**BELL BEND NUCLEAR POWER PLANT  
JOINT PERMIT APPLICATION: PPL RESPONSE TO  
ADMINISTRATIVE INCOMPLETENESS NOTIFICATION  
BNP-2011-210 Docket No. 52-039**

References: 1) J. Dresch, PADEP, to T. L. Harpster, "Acknowledgement  
Letter/Administrative Incompleteness Notification, DEP Application  
No. E40-720", October 25, 2011

Administrative Incompleteness Notification  
DEP Application No. E40-720  
APS No. 753143  
Bell Bend Nuclear Power Plant  
Salem Township, Luzerne County

SHEET TITLE:  
**ENCLOSURE D2 - BBNPP WETLAND & WATERCOURSE IMPACT LOCATION MAP - DEP**  
 Nuclear Power Plant  
 Bell Bend Nuclear Power Plant  
 Luzerne County, PA

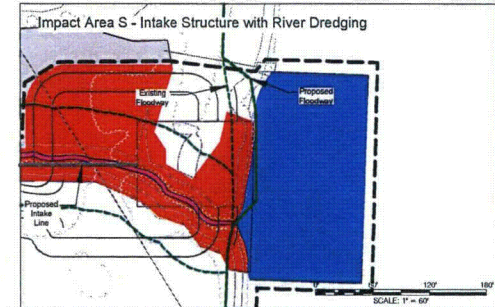
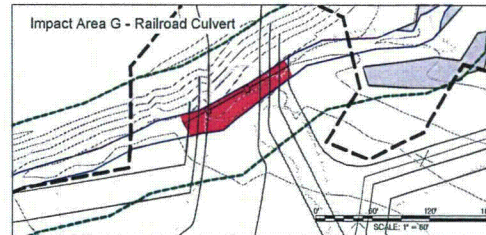
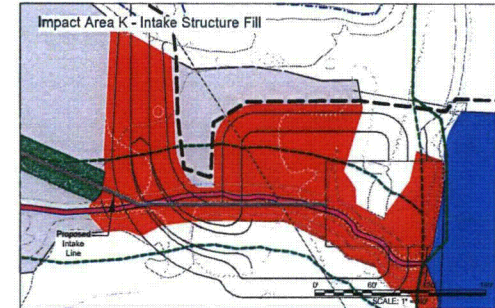
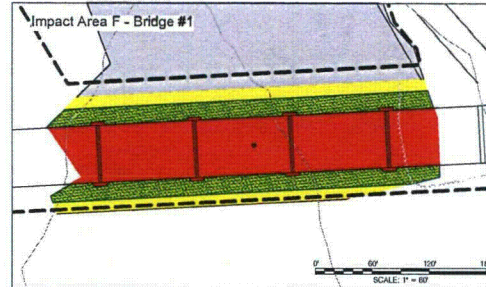
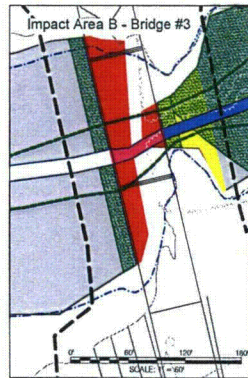
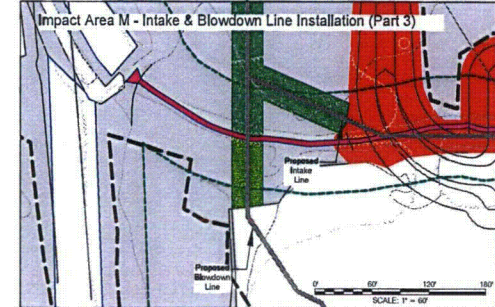
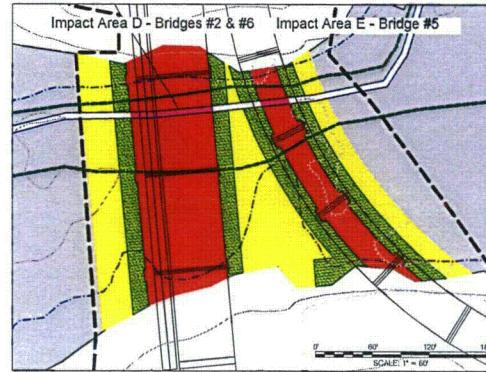
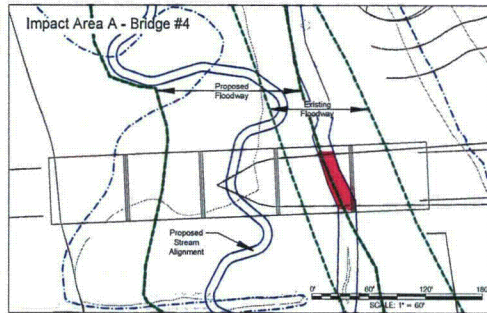
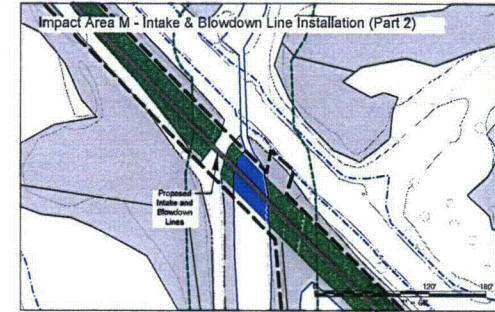
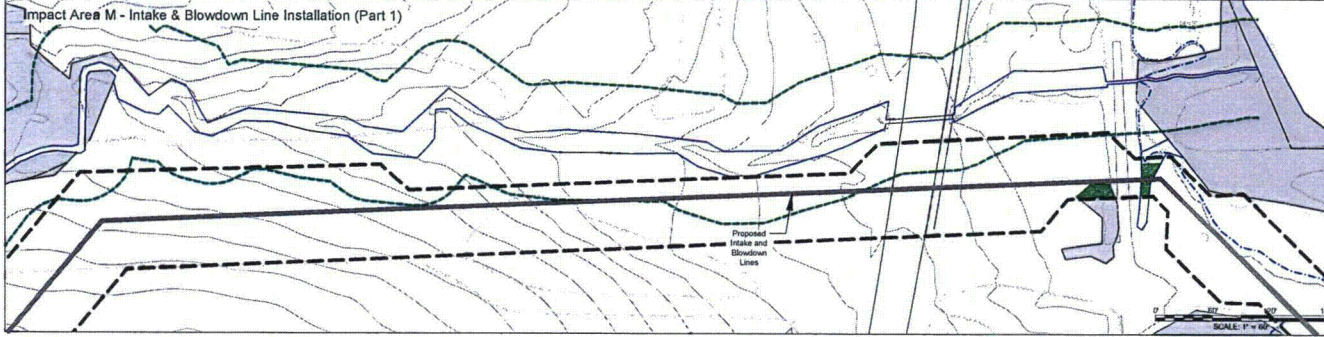
1. Please more clearly define which wetland areas are “to be created” and which wetland areas are existing natural features. This comment is applicable to Impacts: B,C,D,E, I, J, K, M, P, Q, and R.

2. Please provide a delineation of the 100-year floodway and the 100-year floodplain associated with all watercourses impacted by the project. If a FEMA Flood Insurance Rate Map depicting the limits of the 100-year floodway and/or the 100-year floodplain is not available, then the 100-year floodway is assumed to extend 50’ laterally from the point at which the normal water elevation within the stream channel meets the stream’s bank. This comment is applicable to watercourses altered as a result of Impacts: A, B, C, D, E, E, G, H, N, O, U, and V.

**Response:** No wetland creation is proposed in conjunction with any impacts with letter identifiers. All Wetland impacts are depicted in detail on the Impacts Map (Enclosure D2, Section R, Binder 1B). Wetland mitigation areas are shown as a hatched area on the JPA Plans. More detailed information regarding creation and enhancement areas are provided in Section R (Binder 1C) in the mitigation design reports and plans.

**Response:** The floodway has been added to the Impacts Map (Enclosure D2, Section R, Binder 1B). Enlargements have been added to this plan to depict all impacts affecting the regulatory floodway.

SCALE AS NOTED	DRAWING NO. B2-S2
DESIGNED BY ASA	DATE 1-28-11
APPROVED 4-19-11

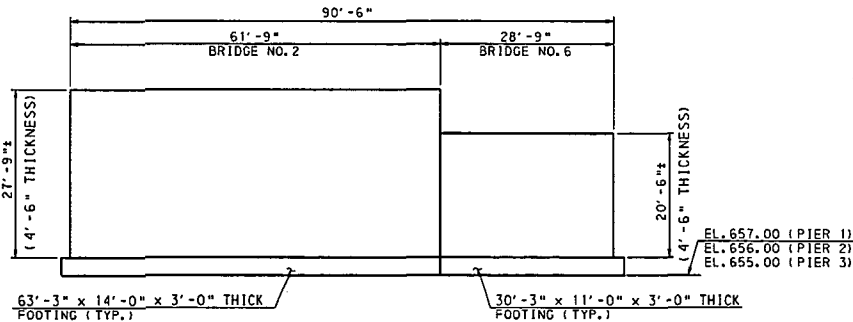
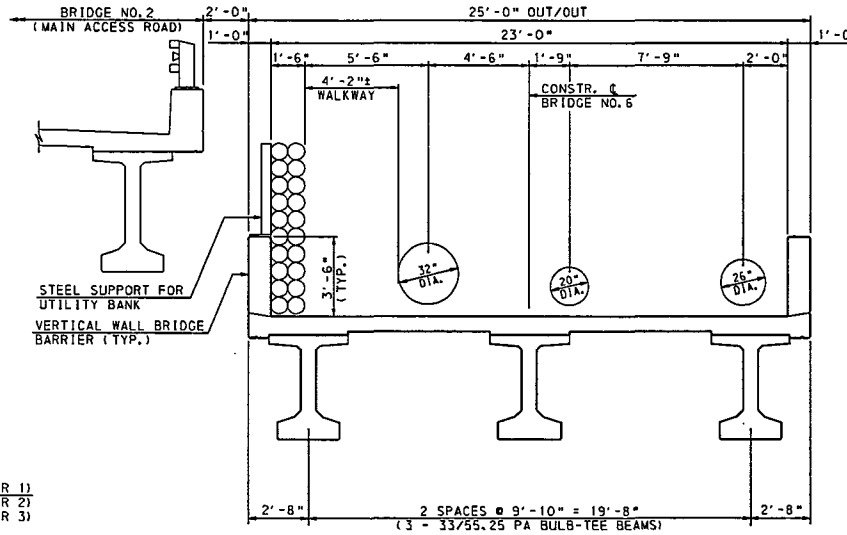
3. Please provide a “utility detail map” on sheet “B2-S2” for Bridge #6.

**Response:** A Utility Detail Table has been added to Sheet B2-S2 of the Bridge Drawings.

SCALE 1" = 25'	DRAWING NO.
DRAWN BY ASA	
DATE 1-28-11	<b>B3-S1</b>
APPROVED 4-19-11

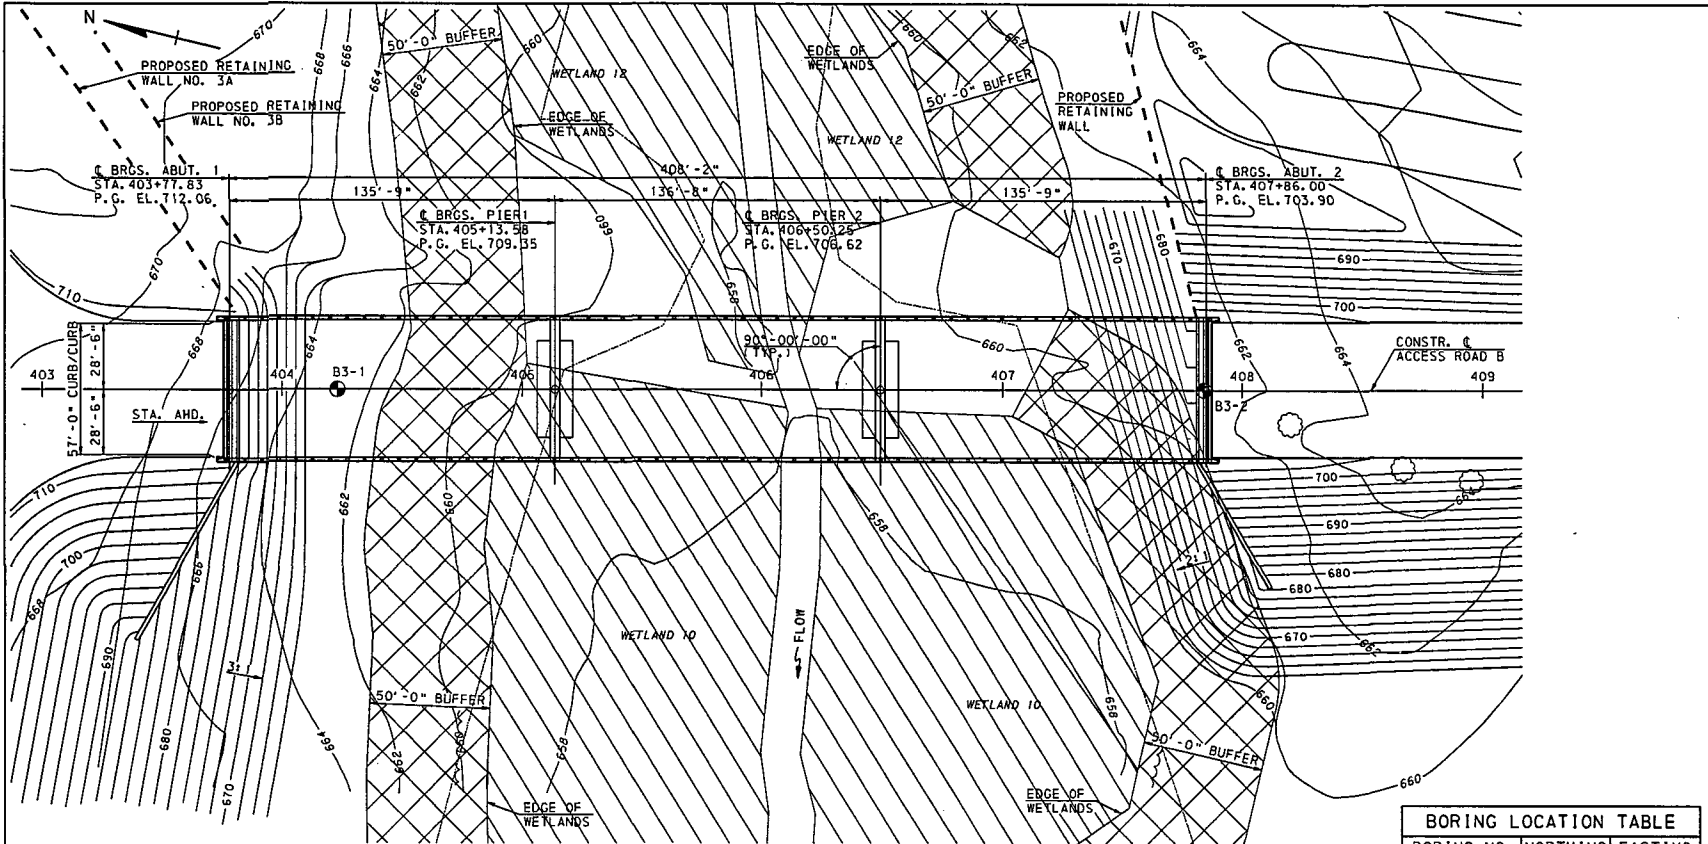
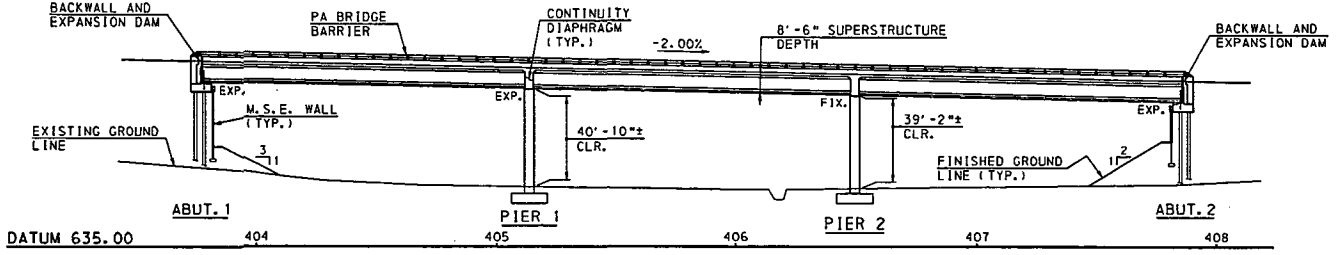
4. Please note that “Wetland #10” on sheet “B3-S1” should be labeled as “Wetland #12.” This comment is applicable to “Impact B.”

**Response:** The existing wetland boundary and wetland labels have been corrected on Sheet B3-S1 of the Bridge Drawings.

DATE	04/15/2011	PROJECT NO.	CS3205
SCALE	AS SHOWN	SHEET NO.	43 OF 44

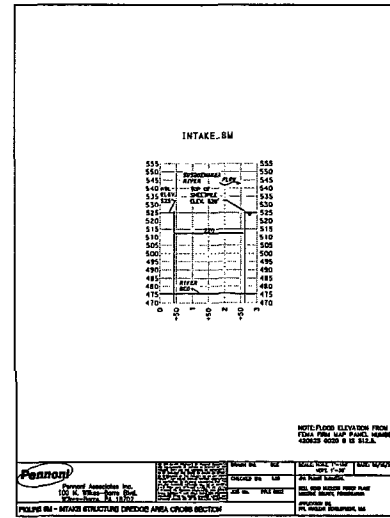
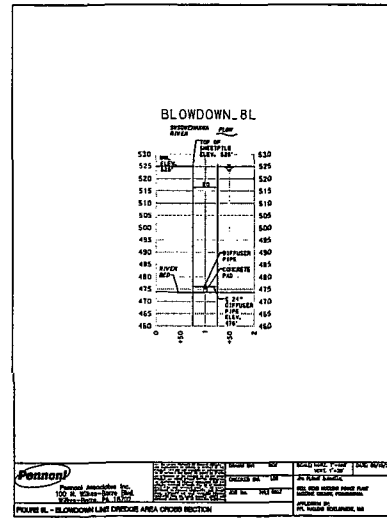
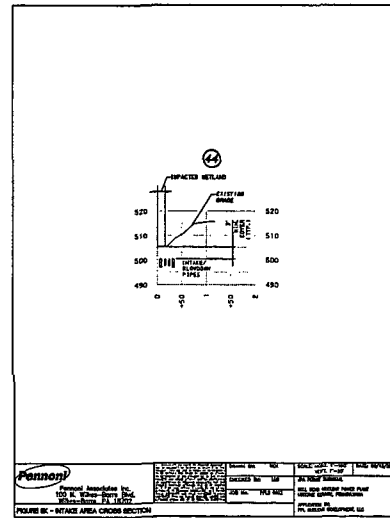
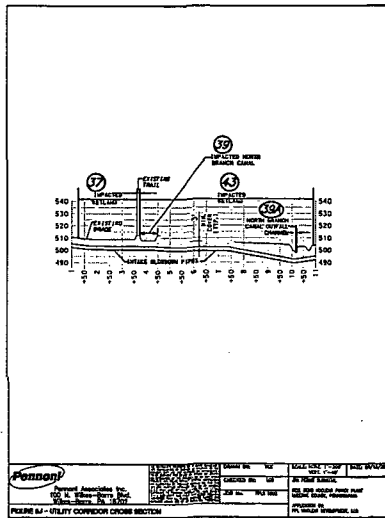
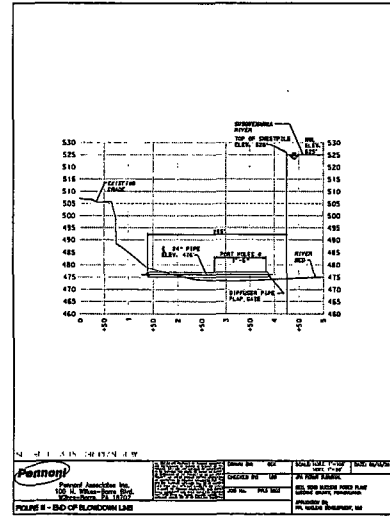
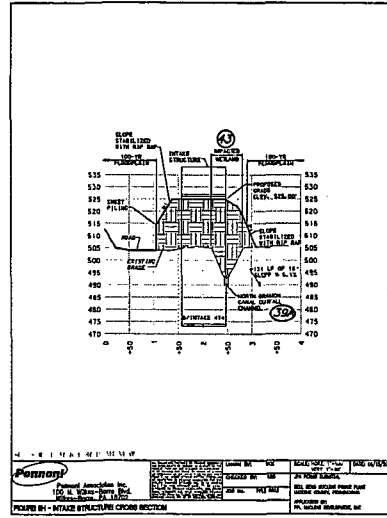
6. Please provide more details on the intake structure ("Impact S") within the floodway.

**Response:** The existing and proposed floodway have been added to Figure 8F on Sheet CS3205 of the JPA Plans (Binder 1A). This figure shows a cross section of the intake structure area, including the existing river bank.

SCALE	AS SHOWN
DATE	
BY	
CHK'D BY	
APP'D BY	
DATE	06/15/2011
PROJECT	
PL	CS3206

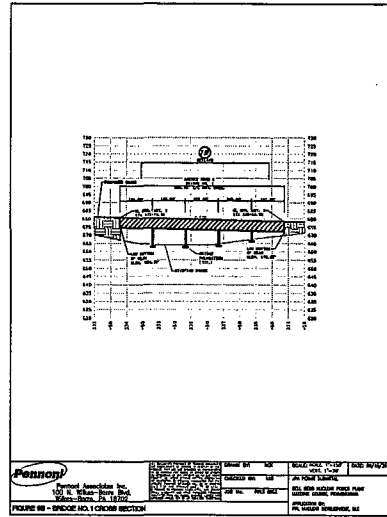
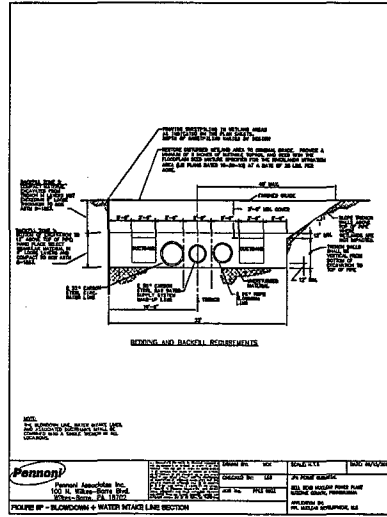
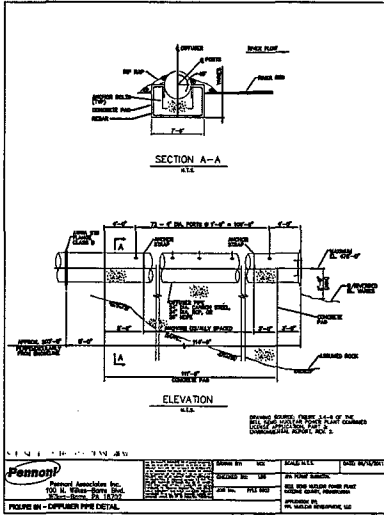
5. Please provide the size and material type utilized for the water intake and blowdown pipeline associated with "Impact M."

**Response:** The sizes and materials of the intake and blowdown lines have not yet been finalized. However, likely sizes and materials have been noted on Figure 8P on sheet CS3206 of the JPA Plans (Binder 1A), with a note that these are subject to final design. Text descriptions have also been added to Section H, Project Narrative (Binder 1) and Section J, Environmental Assessment, Enclosure D (Binder 1B).
